Working Party on the Transport of Dangerous Goods

**Proposals for amendments to Annexes A and B of ADR:
miscellaneous proposals**

Proposal of corrections to 5.3.2.1.4 and 5.3.2.1.6

Transmitted by the Government of Austria*

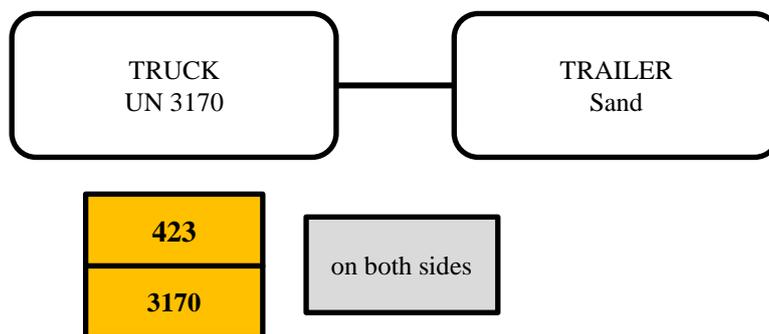
5.3.2.1.4: The term “transport units” could imply a formally correct marking, which is in contrast to the intention of this paragraph. One can eliminate this, by replacing “transport units” by the term “vehicles”.

10. Replace the term “transport-units” by the term “vehicles”:
- When a hazard identification number is indicated in Column (20) of Table A of Chapter 3.2, ~~transport units~~ **vehicles** and containers carrying

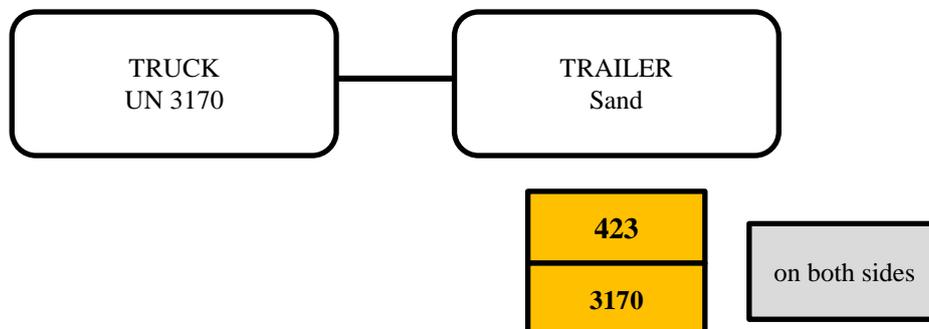
1. This paragraph demands an orange-coloured plate (left side and right side), bearing the hazard identification number and the UN-number, if dangerous solids, articles (unpacked) or radioactive material under exclusive use (single UN-number) are carried.
2. The following example demonstrates the problem, which is addressed in the summary. A transport unit (a truck with trailer) is loaded with UN 3170 (bulk, in accordance with VC1 and AP2 – truck) and with a non-dangerous good (e.g. sand – trailer).
3. The marking in accordance with 5.3.2.1.4 is:

4. The other possibility – which is not in contradiction to 5.3.2.1.4, because only the transport of other dangerous goods is excluded, and the transport unit has to display the orange-coloured plates – is shown below:

5. The second possibility is certainly not intended by 5.3.2.1.4.
